## ***Interactive comment on “A technical description of the Balloon Lidar Experiment BOLIDE” by Bernd Kaifler et al.***

**Bernd Kaifler et al.**

Received and published: 2 June 2020

Fig. 2.

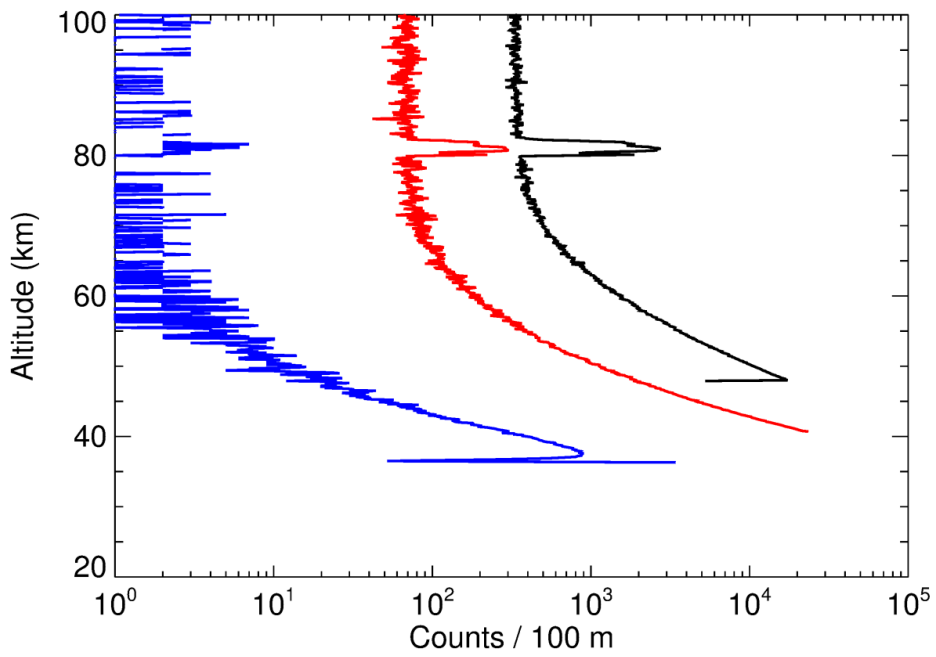
In our case a single detector was sufficient to handle the PMC backscatter signal. However, with the BOLIDE instrument we also wanted to measure Rayleigh temperature profiles below the PMC layer, reaching down as close as possible to the balloon gondola. Figure 2 shows photon count profiles from all three detectors (APD1 (black), APD2 (red), PMT (blue); the gondola was at approximately 37 km altitude). It turned out that defocusing of the telescope in the near field rendered the lower 5-8 km of the profiles useless and, as a result, the third detector exhibited much lower counting rates at low altitudes than anticipated.
